Model Error Resolution Document

INITIATION

1. Originator: Jerry McNeish	2. Date: June 24, 2008	3. ERD No. MDL-WIS-PA-000005 ERD 04
4. Document Identifier: MDL-WIS-PA-000005 REV 00 and AD 01	5. Document Title: Total System Performance Assessment Model/Analysis for the License Application

6. Description of and Justification for Change (Identify applicable CRs and TBVs):

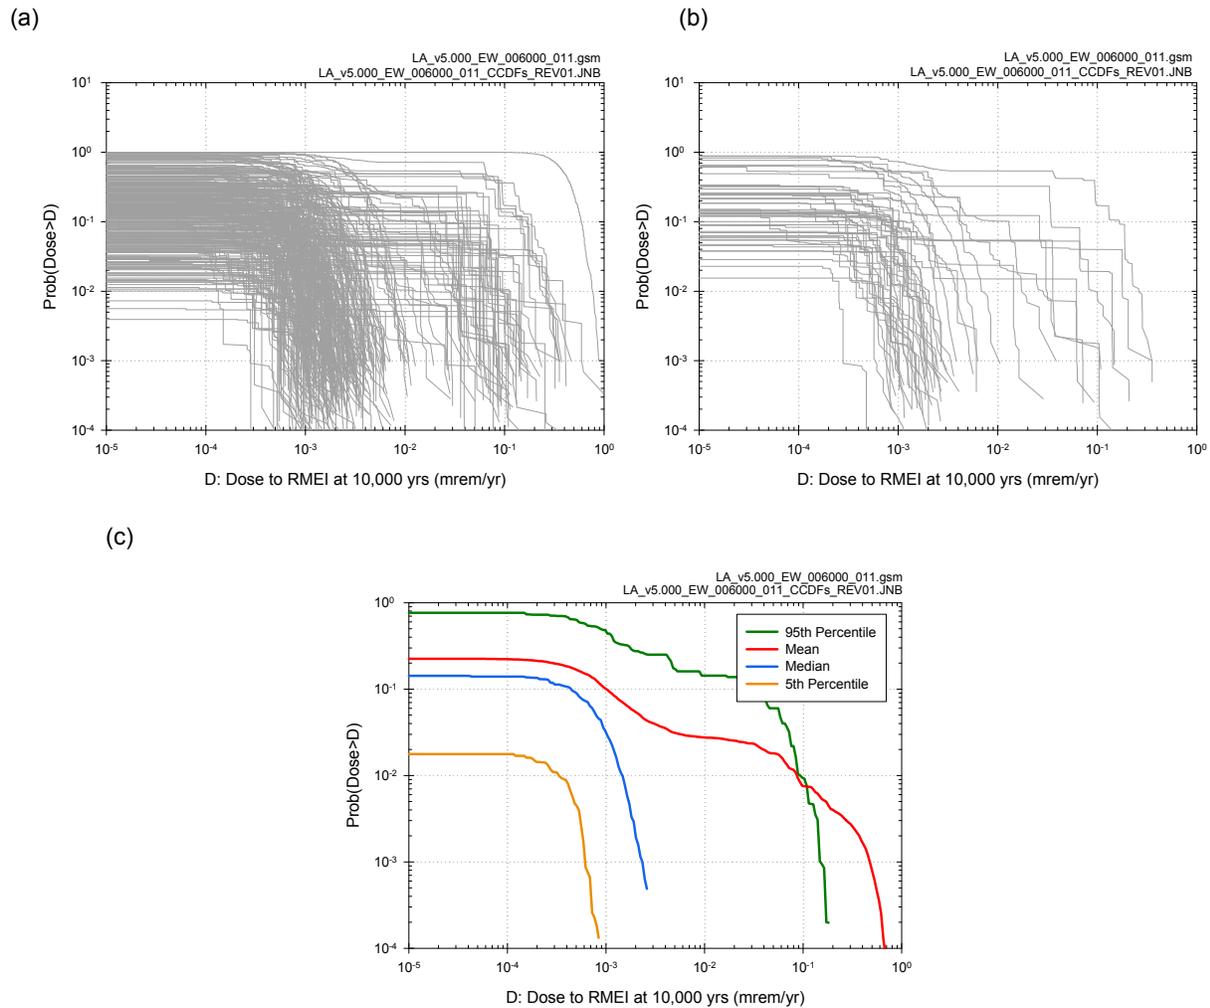
Replace Figure ES-32 on page FES-32 and Figure 7.1-2 on page F7.1-2 with the revised figure below. Remove the NOTE that appears in the caption of Figure 7.1-2.

Note: Numbers located in the upper left corner of the during-development boxes, correspond to the list of Level 1 validation activities found in SCI-PRO-002.

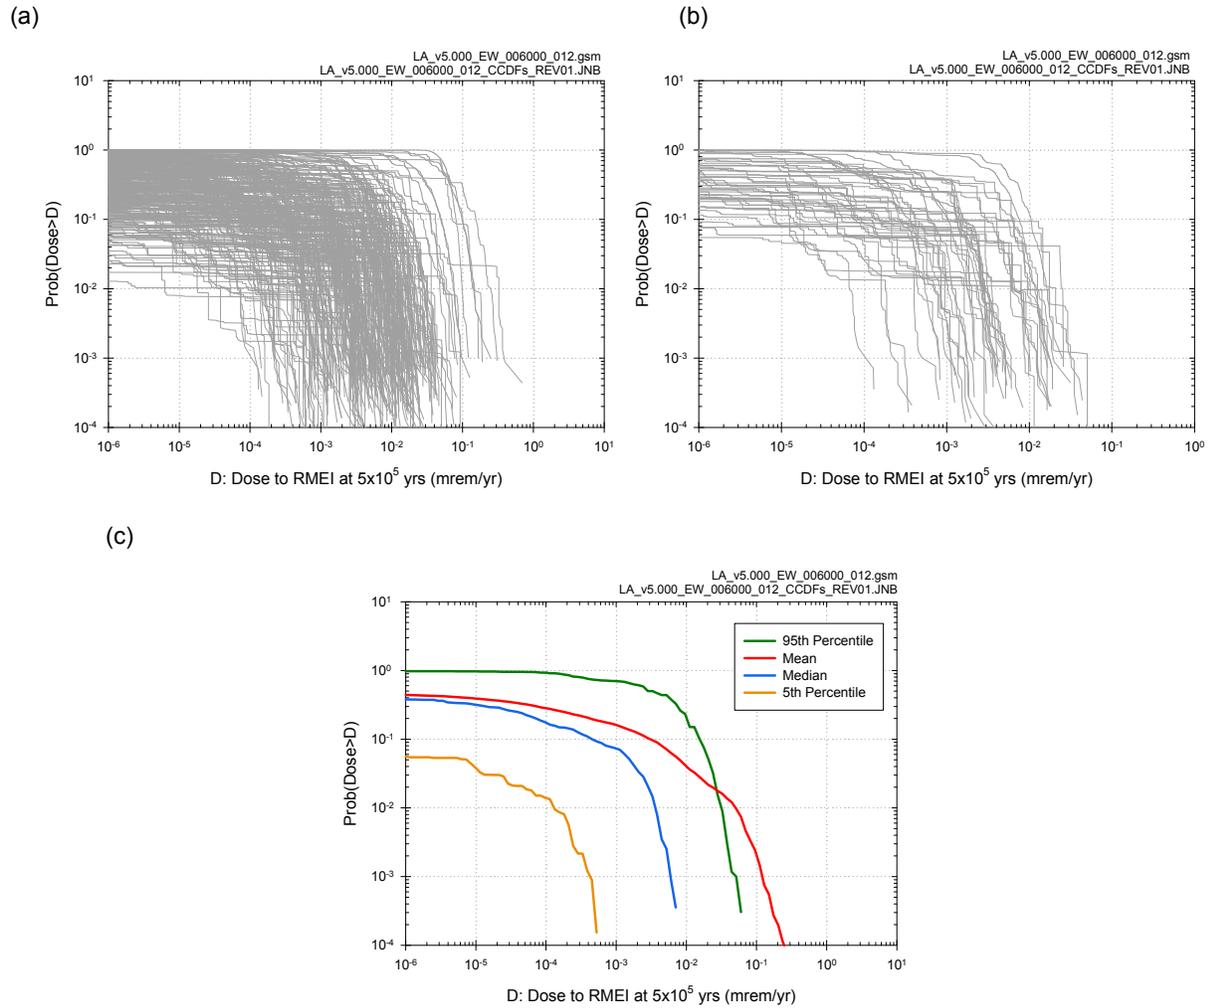
In Appendix J of the TSPA-LA document (Rev00), it has been discovered that several of the plots/figures are not displaying all the data that was available in the SigmaPlot file. The discussion and captions regarding the figures are correct, however, the plots themselves are only showing approximately 160 realizations when they should be displaying 300 realizations. Attachment 2 provides the replacement plots (part (a) on each figure) with all 300 realizations, and the SigmaPlot files are in output DTN: MO0806TSPADCOR.000. Only the figures themselves are affected by this change, therefore, there is no impact on the results or conclusions of the TSPA-LA or SAR.

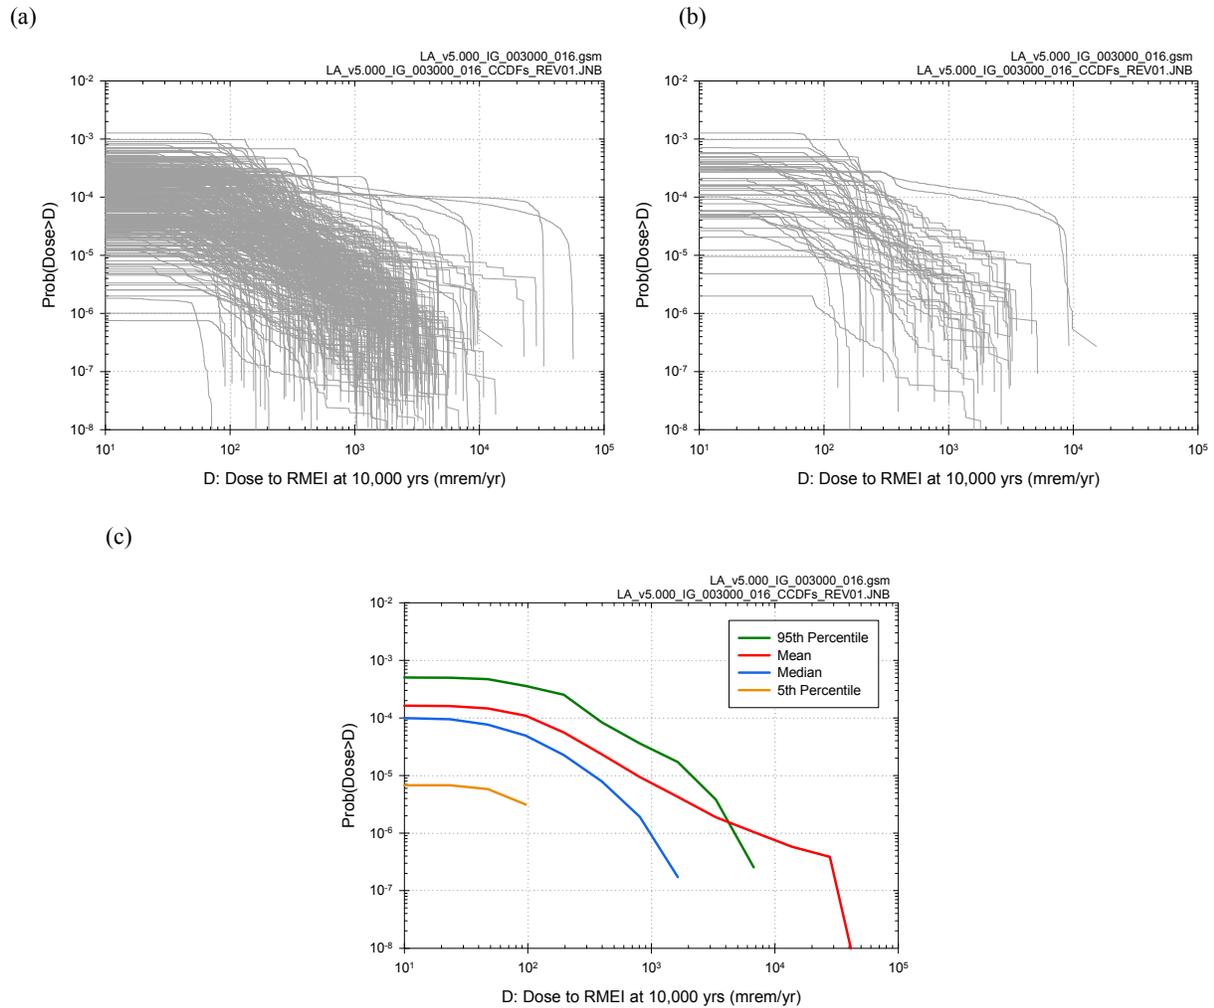
In Appendix J of the TSPA-LA document, a duplicate figure was discovered in Figure J7.2-9 on page FJ-63. The plot illustrated in (b) is the same plot shown in (a). The figure and results are described correctly in the caption and text. However, plot (a) shows 300 realizations, while plot (b) was supposed to show only 50 realizations as indicated in the caption. The entire figure should be replaced with the corresponding one in Attachment 2. There is no impact on results or conclusions of the TSPA-LA or SAR.
